Petition No. 1068
BE 2012A LLC - Bloom Energy
New London, Connecticut
Staff Report
October 31, 2013

Site Plans based on City-Bloom agreement of October 23, 2013.

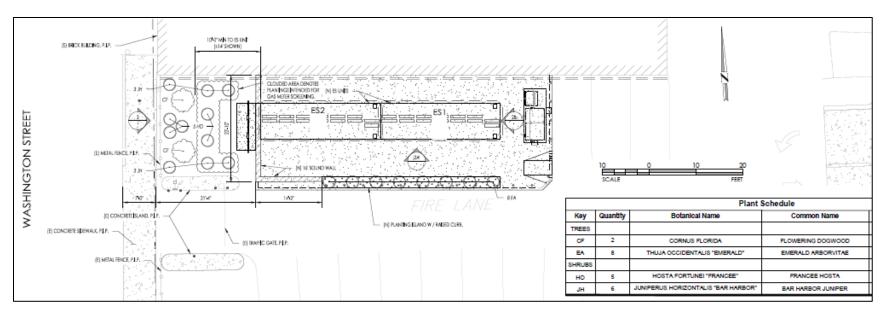
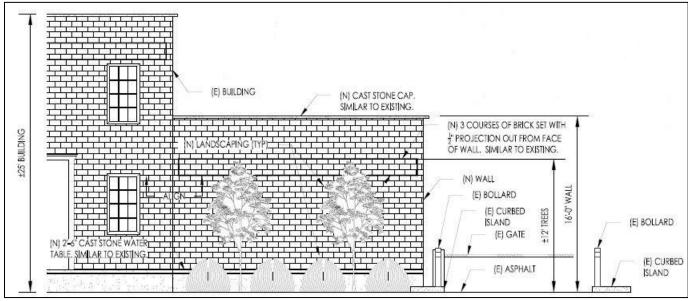
As a result of the City's negotiations with Bloom, Bloom would relocate the fuel cell 21 feet from Washington Street and install a 16-foot tall brick sound attenuation wall on the west side and 14 feet of the south side of the fuel cell. The sound attenuation wall would reduce sound levels to 45 dBA or less at the residential units at 13 Washington Street. Noise from the site would comply with State noise control regulations and the City's noise ordinance.

The east side of the fuel cell would remain open, allowing access from the existing parking lot. Landscaping featuring a variety of shrub plantings would be installed between the sound wall and Washington Street. The gas meter would be located along the west side of the sound wall, screened by the plantings. A raised curb with arborvitae plantings would be installed along the south side of the fuel cell facility.

Staff recommends approval with the condition that the brick sound attenuation wall be designed and constructed in accordance with appropriate building codes and wind loading criteria for New London County. The design and construction of the wall shall be certified by a structural engineer duly licensed in the State of Connecticut.
